Product Change Notification

Change Notification #: 117238 - 00

PCN 117238 - 00, Product Design, Label, Firmware and FPGA Updates, Regulatory Label Addition

Figure 1. 100SWDLF32Q Regulatory Label

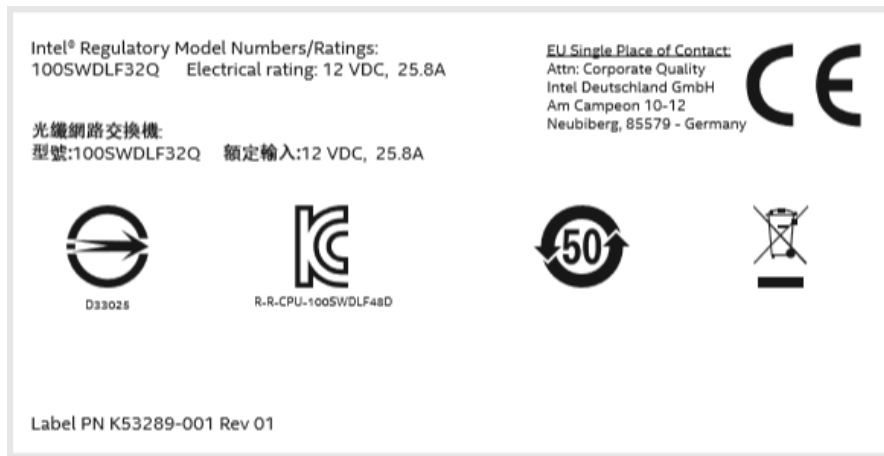
Change 1: In order to facilitate shipment of leaf modules into Korea and Taiwan, a dedicated Registration of Compatibility and associated label, independent of the Director Class chassis, will be added. These regulatory labels are shown in **Figure 1** and **Figure 2** below.
